Access Compliance Report Public Rights-of-Way (Curb Ramps)

Main Street: AVENIDA_LA_PATA Cross Street: VISTA_MONTANA Location: SW

ADA ID: RPRK211201120737 Ramp Type: Type 1 - Perpendicular Diagonal Initial Pass/Fail: Fail Overall Compliance: No Severity Score: 30

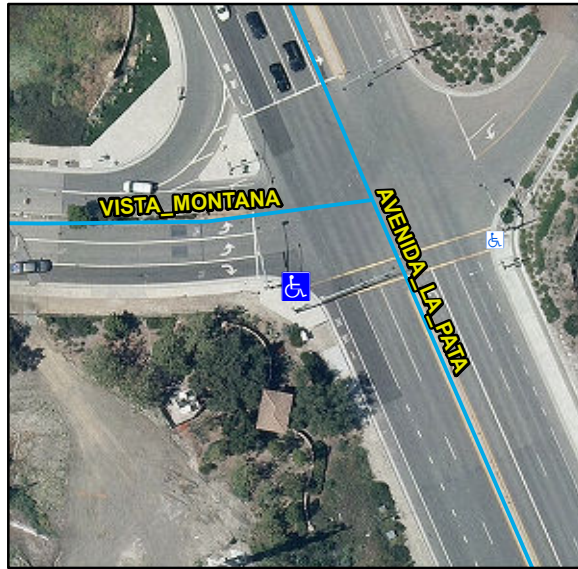
R304.2.2, R304.5.3, STD 1115

Remove & Replace Curb Ramp With Two New Directional Ramps or Equivalent.
